Office Action Summary

10/072,247

COOK, DANIEL J.

DETAILED ACTION

FIG. 1

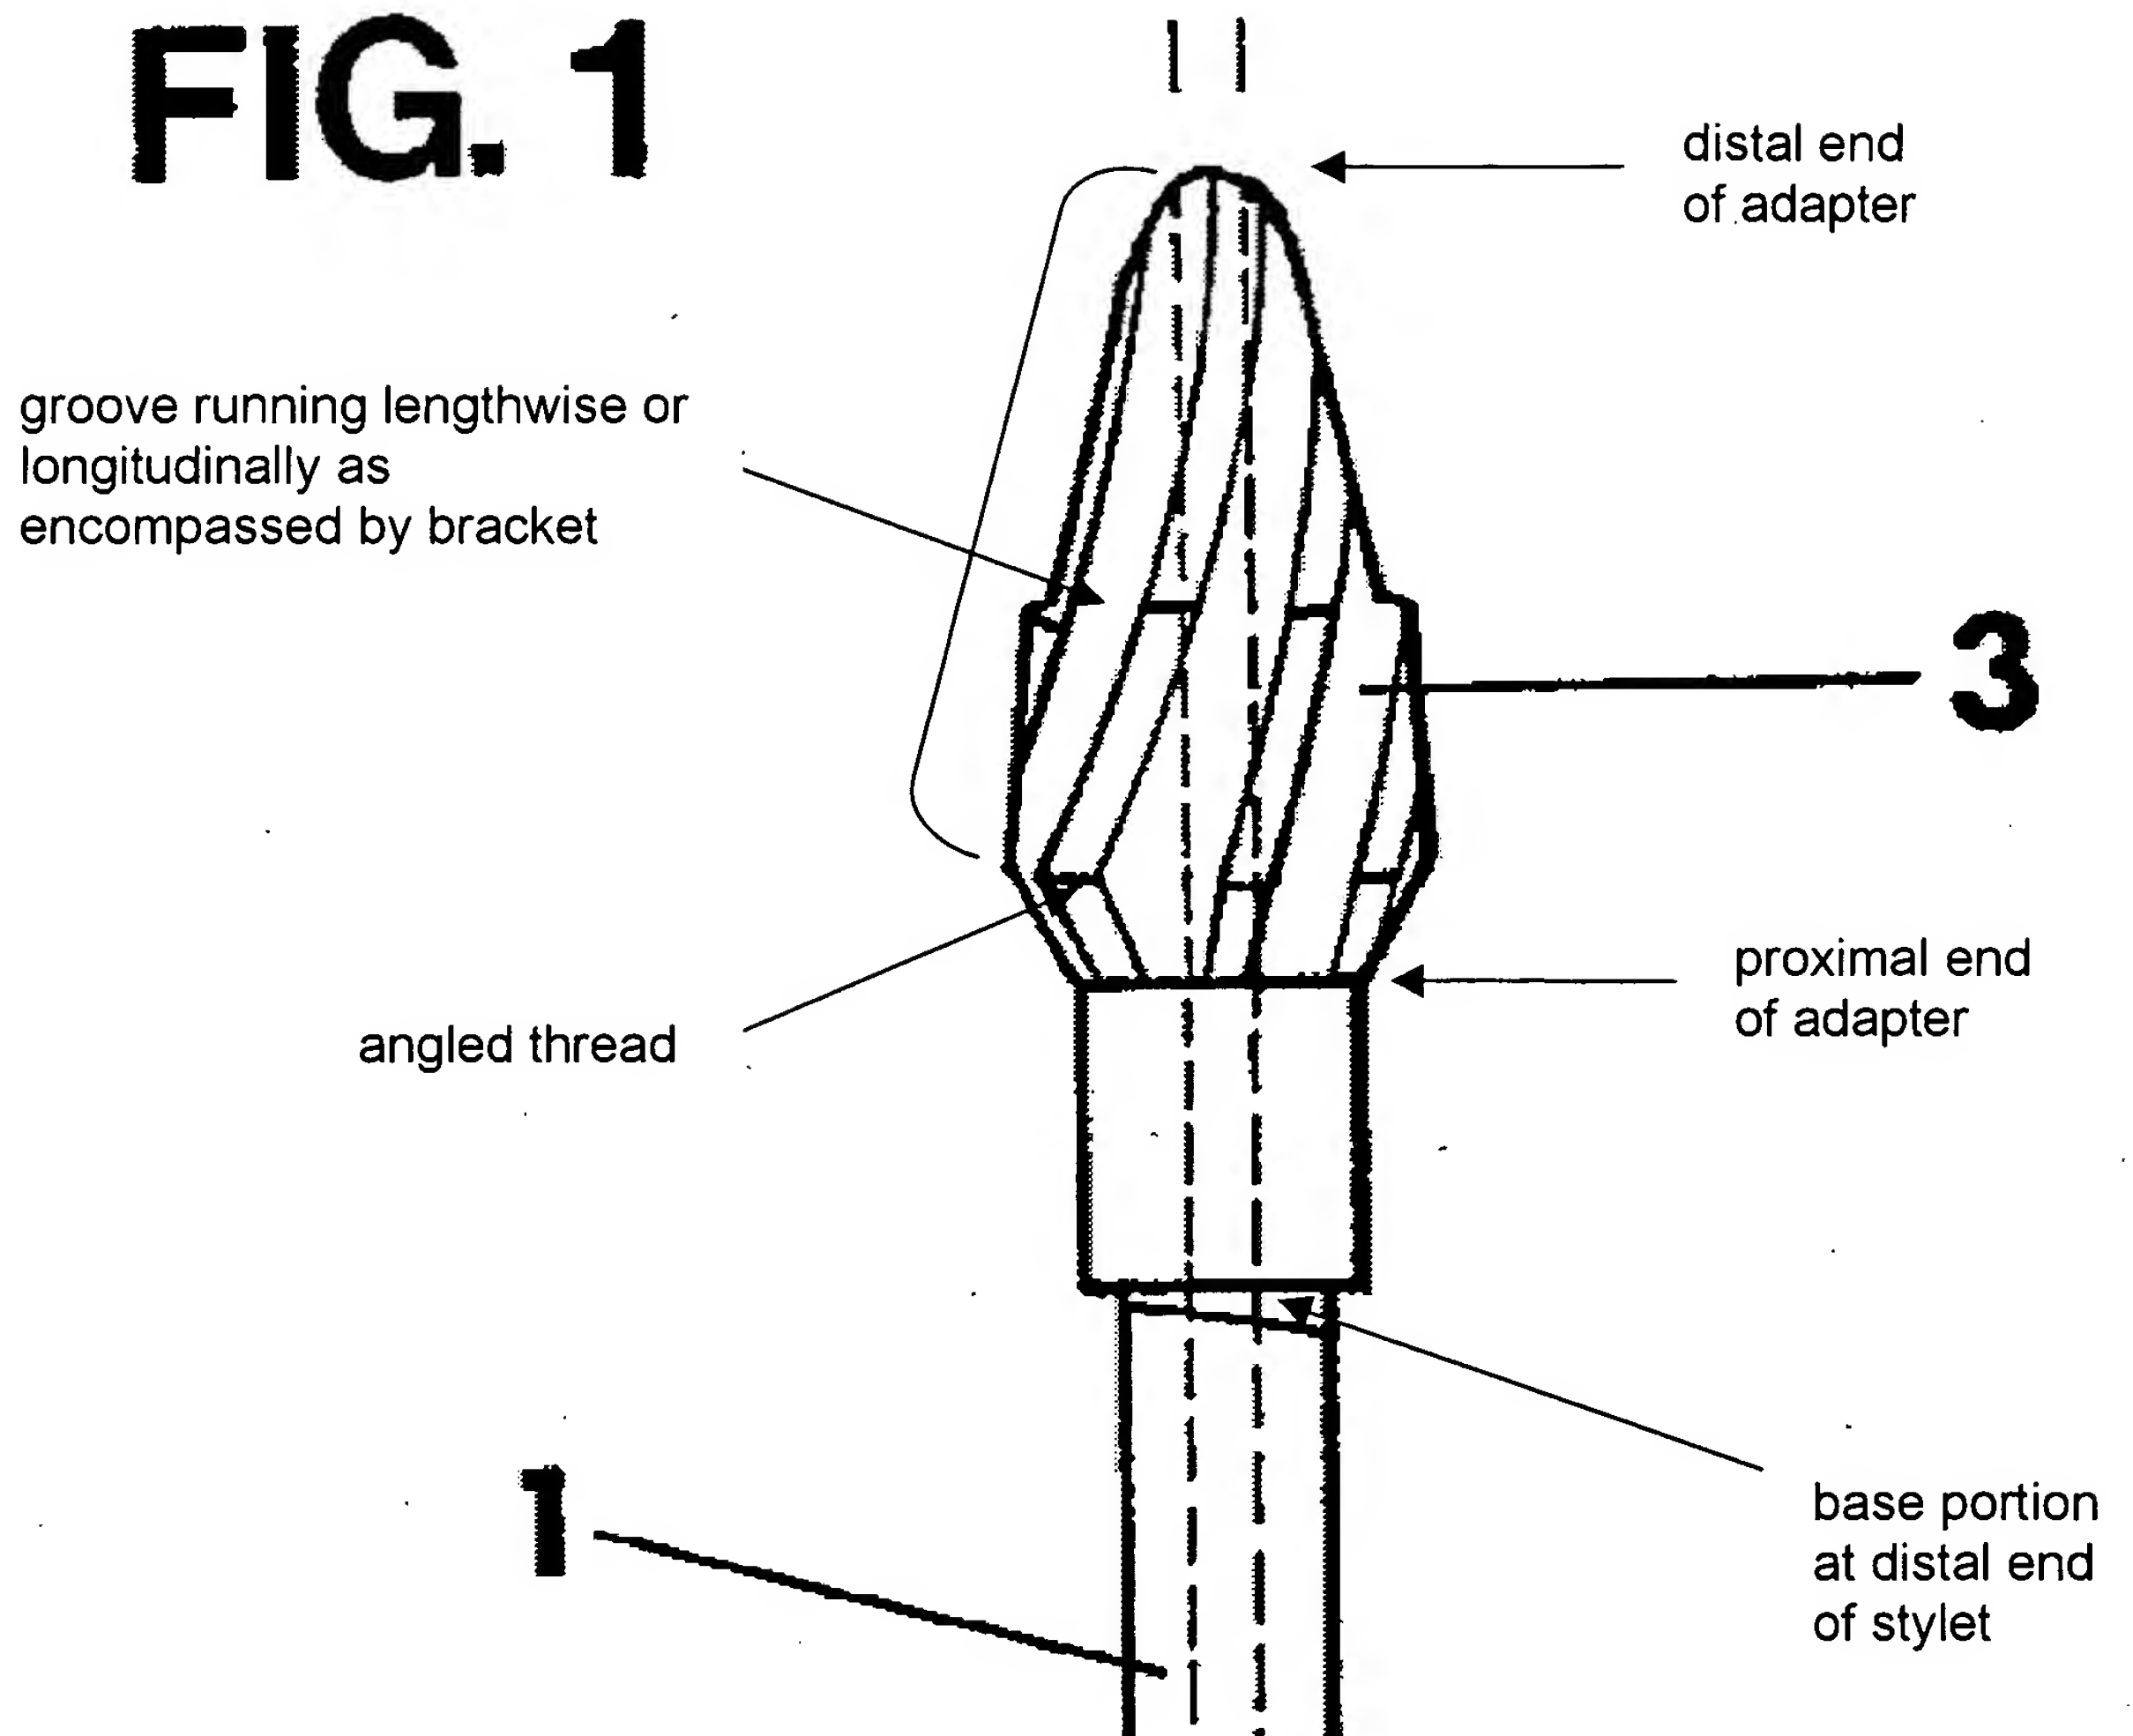
10. **As to claim 6**, DiPietropolo teaches an endo-tracheal tube retainer wherein an exterior surface of the connection adapter 3 comprises a plurality of longitudinal grooves **(Please see Fig. 1 attachment below; Also note that longitudinal is defined in Merriam-Webster's Collegiate Dictionary, 10th Ed. as placed or running lengthwise and the Examiner considers DiPietropolo to teach grooves running lengthwise on the adaptor from one end lengthwise to the other end; furthermore, Applicant recites longitudinal grooves on an exterior surface and does not recite longitudinal grooves running along the entire length of the exterior surface of the adaptor)** permitting passage of air and fluids past the endo-tracheal tube retainer after insertion within an endo-tracheal tube; and a plurality of threads angled **(See Fig. 1 attachment below)** to facilitate insertion of said endo-tracheal tube retainer within an endo-tracheal tube, but hindering withdrawal of said endo-tracheal tube retainer from said endo-tracheal tube **(Please note that given the structure the device is inherently capable of performing the functions set forth)**.

11. **As to claim 8**, DiPietropolo teaches an endo-tracheal tube retainer wherein the longitudinal grooves are equi-spaced around the connection adapter 3 exterior surface **(See Fig. 1 attachment below)**.

12. **As to claim 9**, DiPietropolo teaches an endo-tracheal retainer wherein there are at least four longitudinal grooves **(See Fig. 1 attachment below; please note only 3 are shown, the remaining grooves being on the other side of the adapter)**.

adaptor) permitting passage of air and fluids past the endo-tracheal tube retainer after insertion within an endo-tracheal tube; and a plurality of threads angled (**See Fig. 1 attachment above**) to facilitate insertion of said endo-tracheal tube retainer within an endo-tracheal tube, but hindering withdrawal of said endo-tracheal tube retainer from said endo-tracheal tube (**Please note that given the structure the device is inherently capable of performing the functions set forth**).
